GLA Energy Comments – Updated Design Response

9,11 & 19 Osiers Road, Wandsworth, London

Prepared by: Hollybrook Limited

September 2019

Appendix 4: PV Overshading Analysis

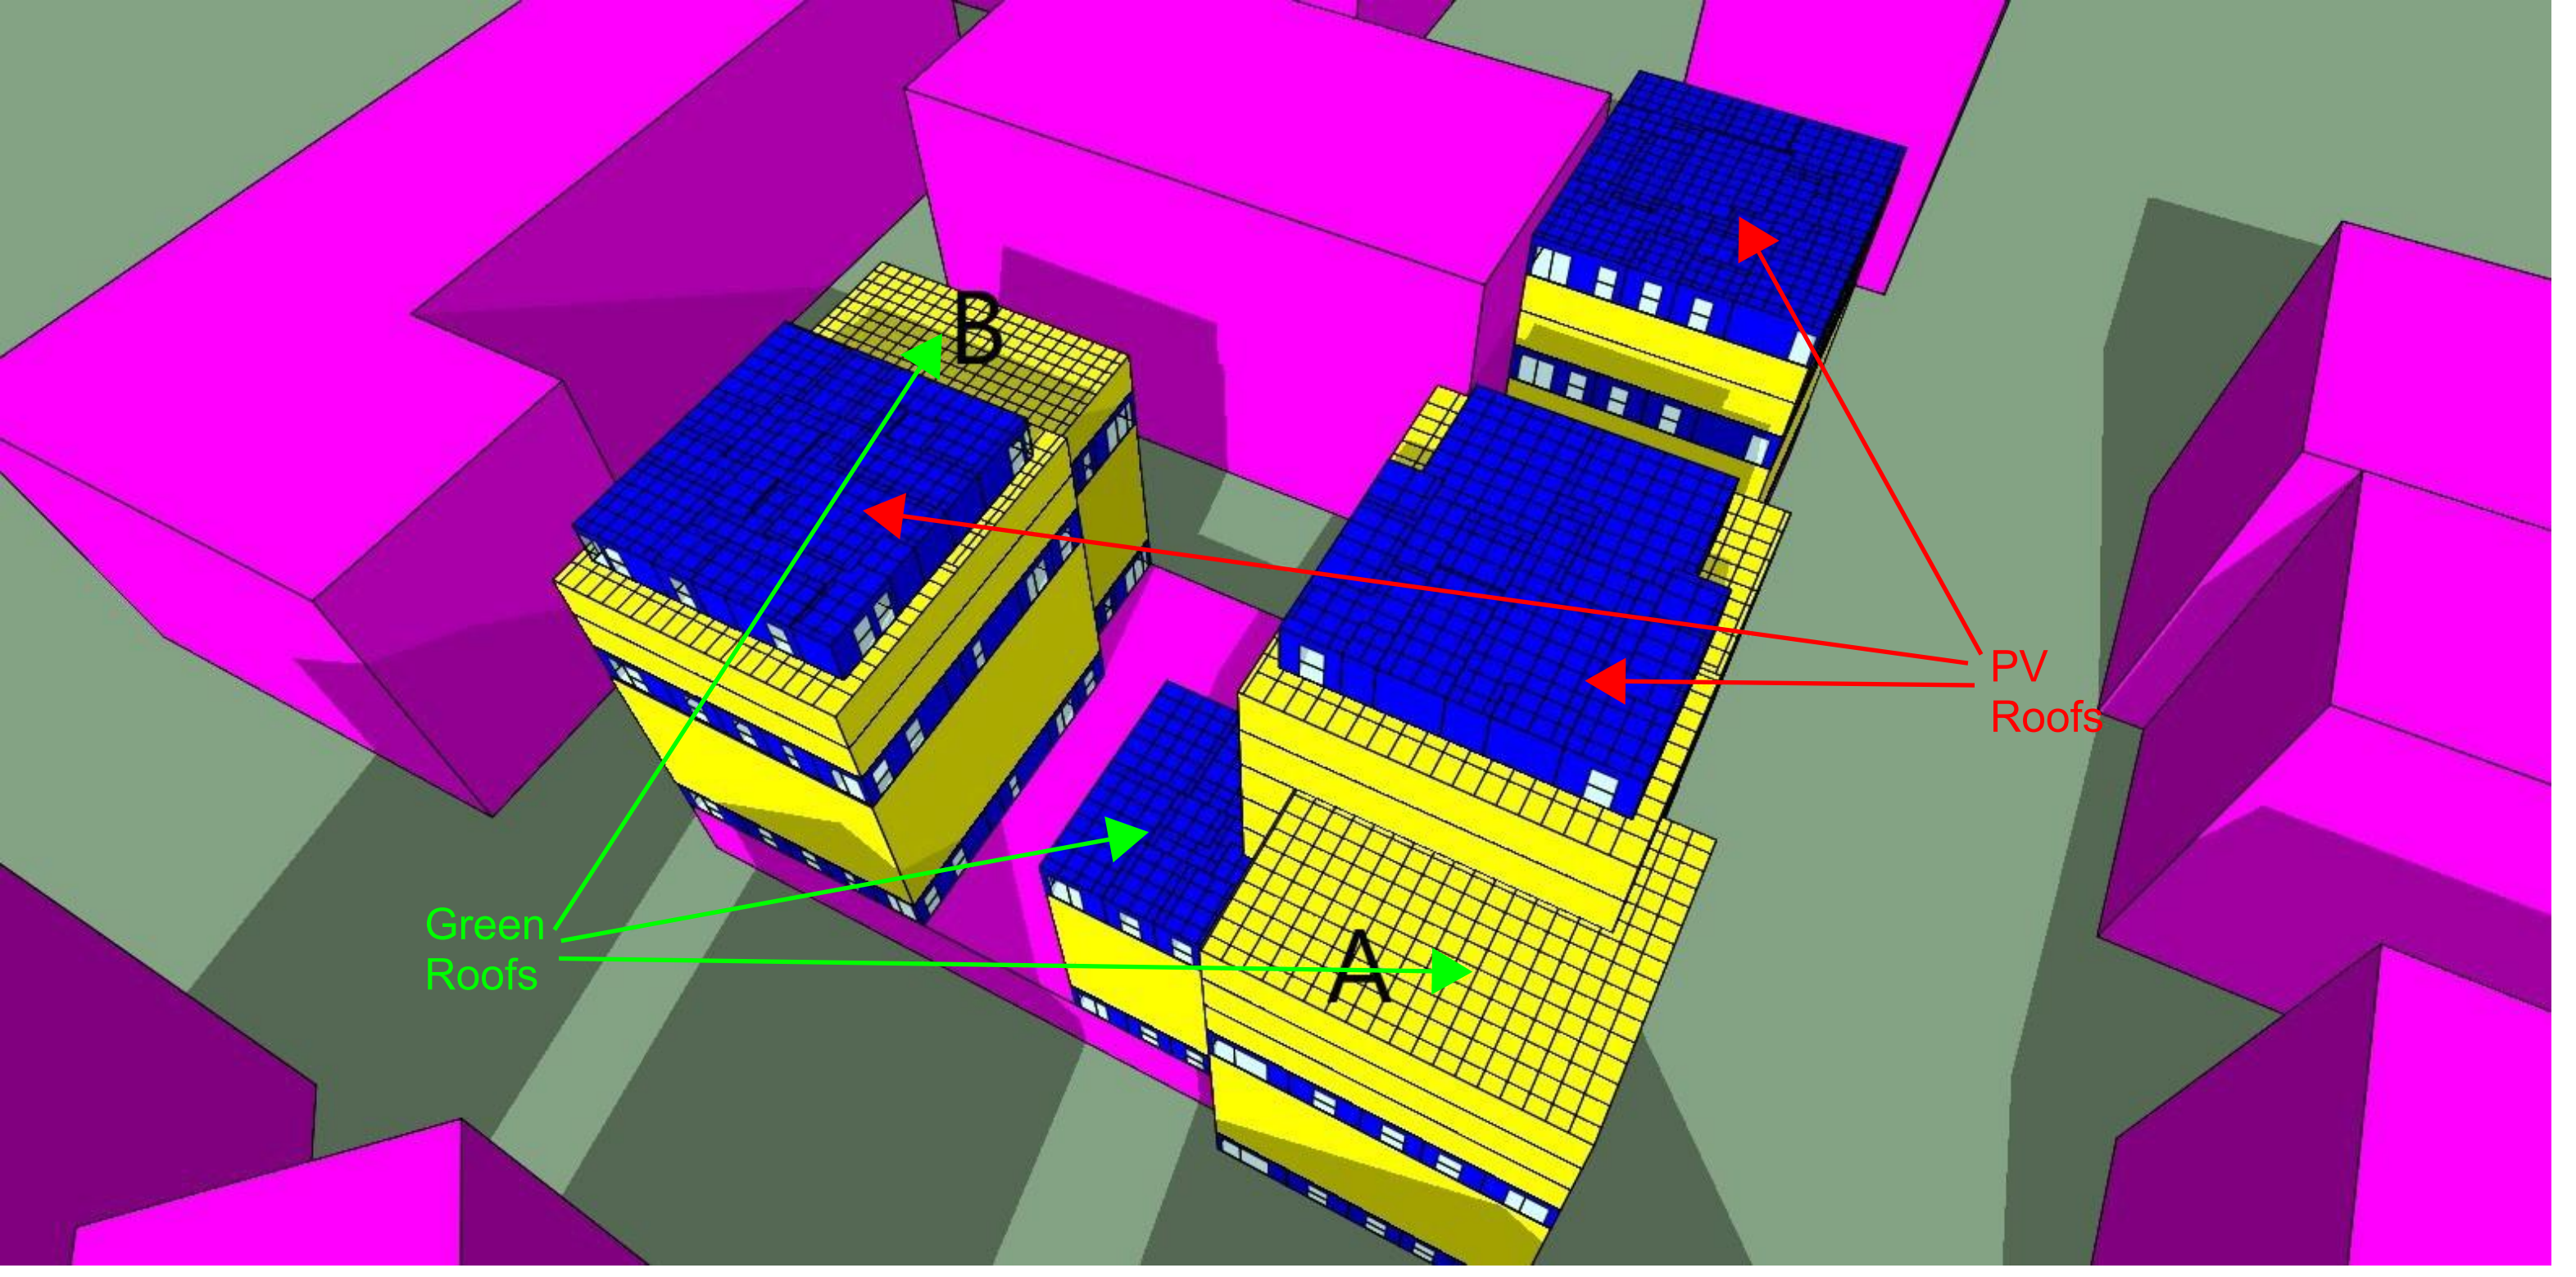
15. A PV array with a rated output of 48kWp is being proposed. A roof layout should be provided indicating the proposed PV installation. The applicant should also confirm the proposed PV area and demonstrate that the site's full potential for a PV installation has been maximised, regardless of the on-site London Plan target having been met.

A PV layout has been provided demonstrating the PV allocation. It has been stated that PVs to lower roofs would suffer from over-shading, and require additional inverters, cabling and maintenance. An over-shading analysis for the lower roof areas should be submitted to support the above statement. This item is still outstanding.

PV is currently proposed to all high-level roof space. The southern lower roofs could feasibly include PV however, this would impede the visual amenity for residents. These roofs are currently proposed as green roofs for this reason.

The current proposals exceed the on-site target of a 35% SAP carbon reduction. The northern lower roof would suffer from shading from the higher floors to its immediate south, in addition to the above impact. An overshading analysis has been provided for the lower roof areas (See Appendix 4).
